Access Compliance Report

Public Rights-of-Way

(Curb Ramps)

Intersection ID: 47966	Main Street: MESA_VERDE_RD	Cross Street: TOM_SHORT_RD	Location: NE
ADA ID: 2C89B005CA09	Ramp Type: PerpDiag	Initial Pass/Fail: Fail	Overall Compliance: No
			Severity Score: 21.25

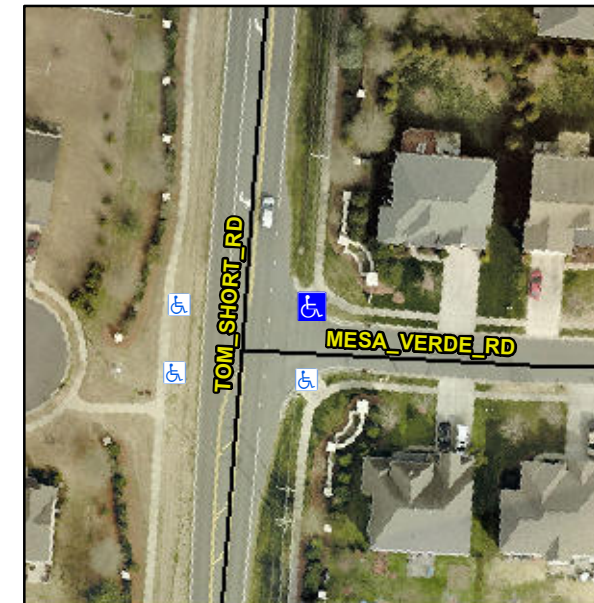
Not Found, R304.5.1, R304.5.3

Compliance	Description	Data	Compliance	Description	Data
N/A	Ramp Length (in)	149.0	Yes	Ramp Slope (%)	7.8
No	Ramp Width (in)	46.0	No	Ramp XSlope (%)	5.2
N/A	Flare Type LT	N/A	N/A	Flare Type RT	N/A
N/A	Flare Slope LT (%)	N/A	N/A	Flare Slope RT (%)	N/A
N/A	Flare Traversable LT?	N/A	N/A	Flare Traversable RT?	N/A
N/A	Landing Length (in)	N/A	N/A	DWS Provided?	N/A
N/A	Landing Width (in)	N/A	N/A	DWS Contrast?	N/A
N/A	Landing Slope (%)	N/A	N/A	DWS Length (in)	N/A
N/A	Landing X Slope (%)	N/A	N/A	DWS Full Width?	N/A
N/A	Landing Curb? (Y/N)	N/A	N/A	DWS Offset (in)	N/A
N/A	Shared Landing?	N/A			
N/A	Gutter Ponding?	N/A	N/A	Gutter Slope (%)	N/A
N/A	Gutter Lip Ht (in)	N/A	N/A	Gutter X Slope (%)	N/A
N/A	Painted X Walk1?	No	N/A	Painted X Walk2?	No
	X Walk 1 Direction	To NW		X Walk 2 Direction	To SW
N/A	X Walk 1 Width (in)	N/A	N/A	X Walk 2 Width (in)	N/A
	X Walk 1 Slope (%)	4.1		X Walk 2 Slope (%)	0.4
	X Walk 1 X Slope (%)	2.1		X Walk 2 X Slope (%)	2.8

Remove & Replace Curb Ramp With Two New Directional Ramps or Equivalent.
